S M Knitwears Ltd

13th April 2014

Observations

Building 1 (Original): High Column Loads

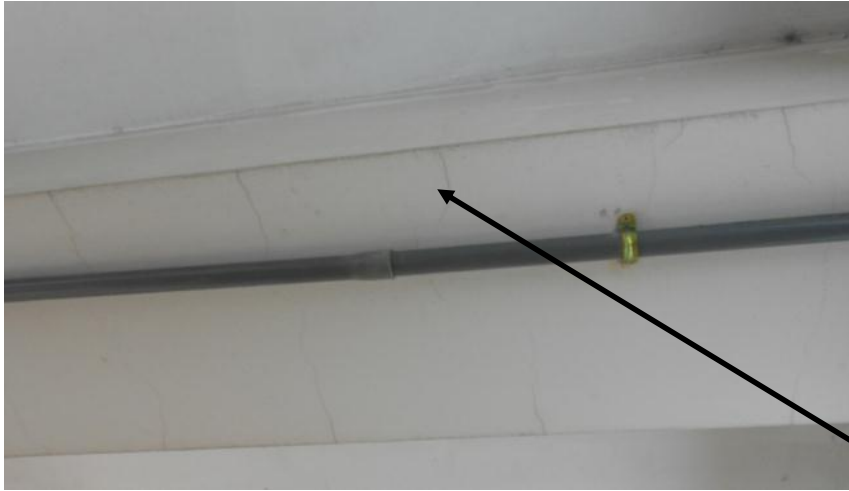
Preliminary calculations indicate that column working stress is at a high level in Building 1 (Original).

A Detailed Engineering Assessment of the building is required (see attached scope). The engineer is to perform detailed calculations based on the 'as constructed' structural arrangement, material properties and loading to verify column size suitability. If required, column loading shall be reduced, and columns possibly strengthened.

Building 1 (Original): Stability of Rooftop Steel Frame

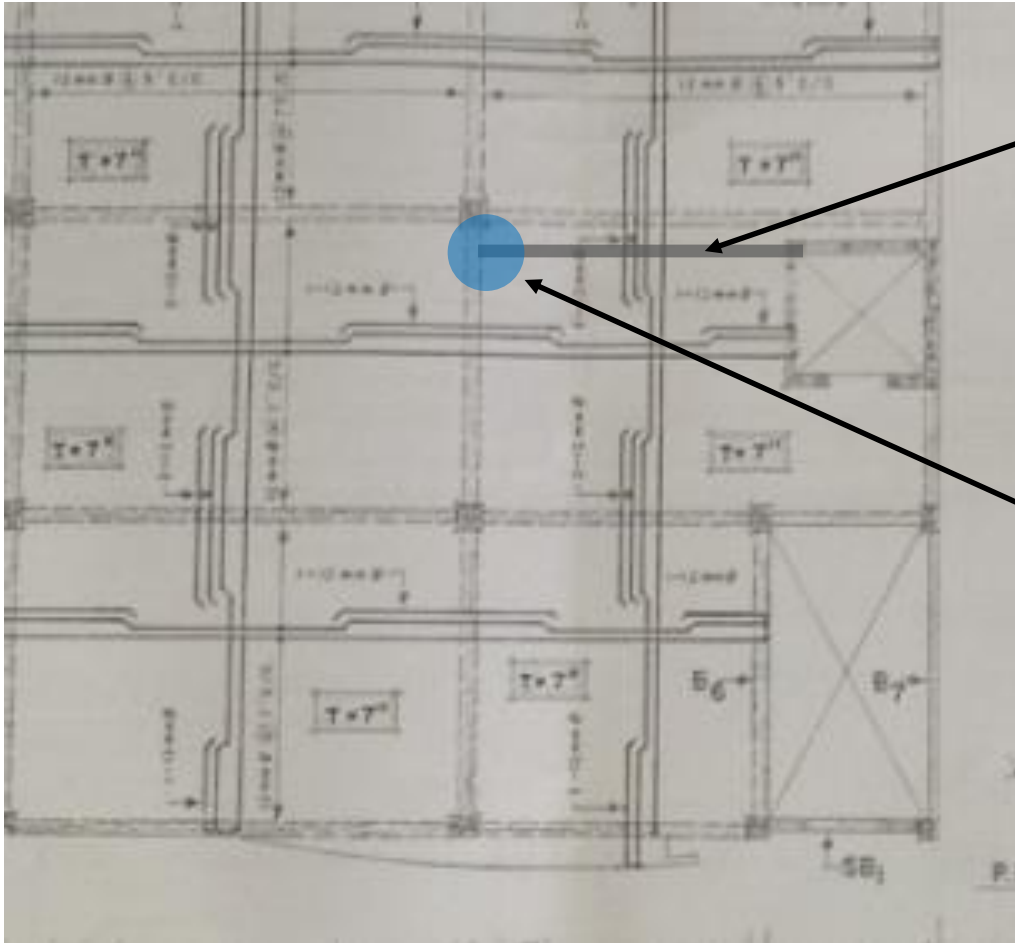
Trusses assumed installed at a later date than main steel frame.

Cross-bracing.

The stability system of the 8.2m high steel roof appears inadequate for design wind load. Building Engineer to review and design the steel frame for design wind loads.

Building 1 (Original): Broken Panes of Glass to Main Facade

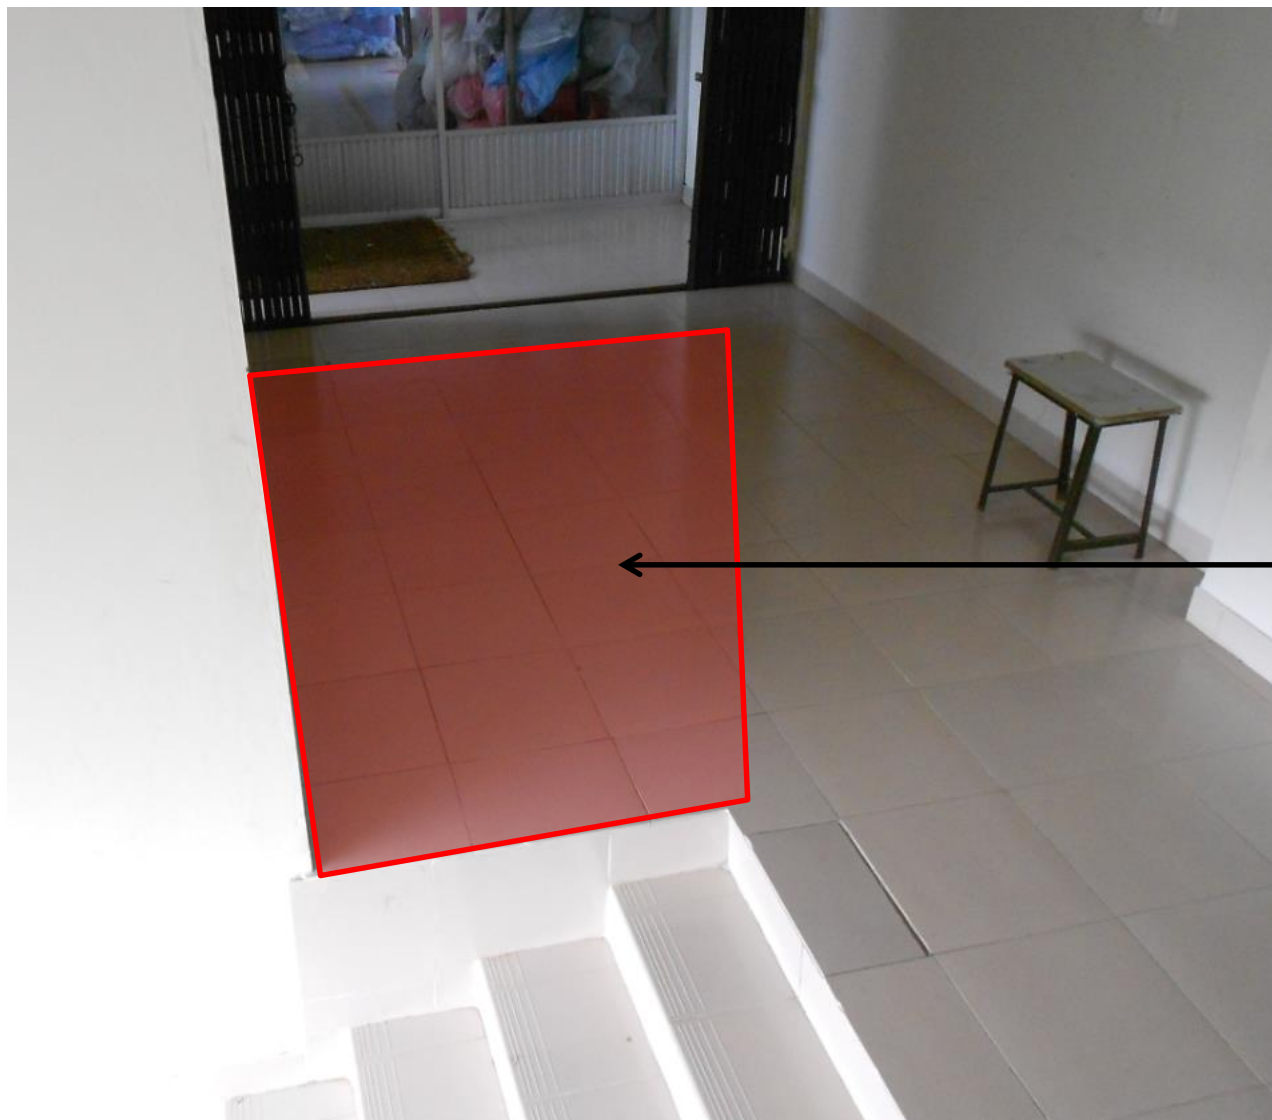
Broken panes of glass to main façade presents a significant safety risk to pedestrians on road below and building users.

Building 3: Deep External Excavation Adjacent to Façade

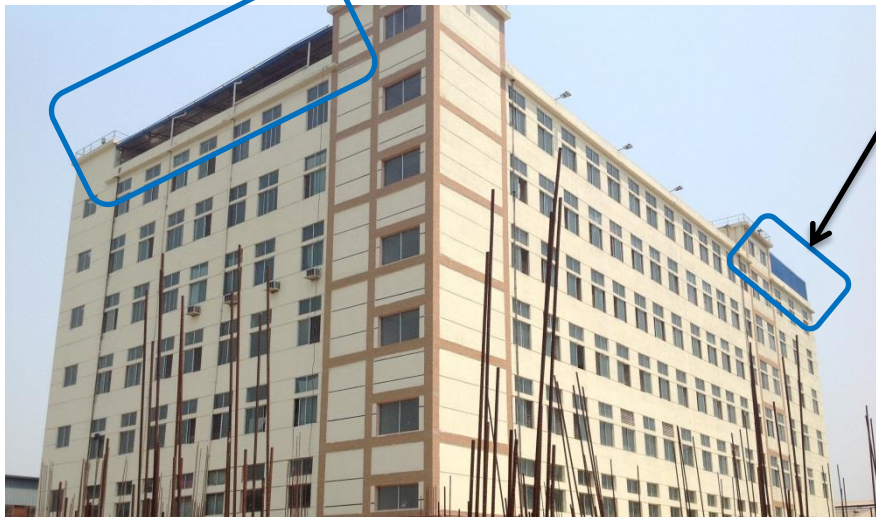
Approximately 4m deep excavation for water treatment plant adjacent to west end of Building 3. The interaction between this excavation and the existing foundations of Building 3 is unknown.

Ancillary Buildings: Apparently Non-Engineered Structures (Finishing Unit)

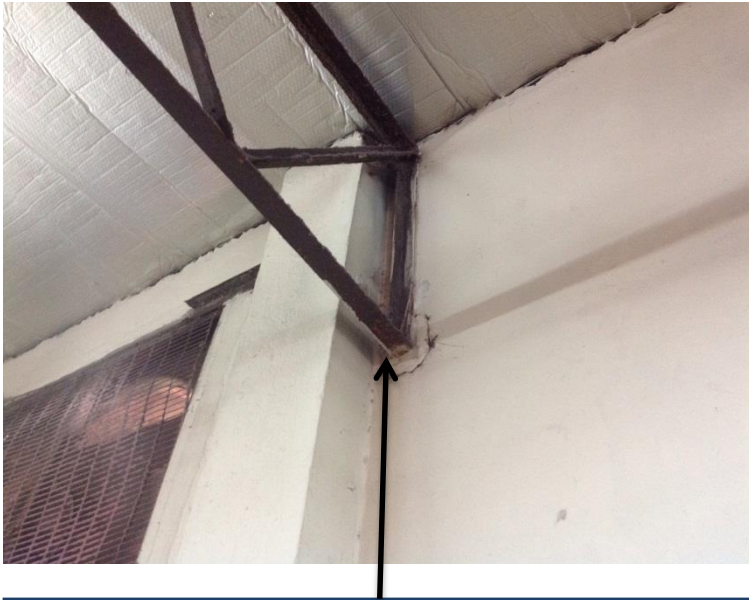
Mezzanine floor within Finishing Unit does not appear to be tied to main steel frame and there is no clear stability load-path.

Ancillary Buildings: Apparently Non-Engineered Structures (Washing Unit)

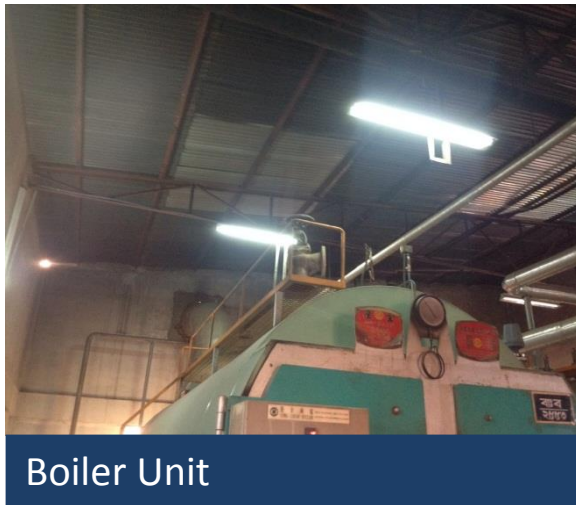
The roof structure to the Washing Unit appears to be non-engineered. Stability load-paths are unclear. Where trusses bear onto masonry walls there are signs of movement between the steelwork and brickwork.
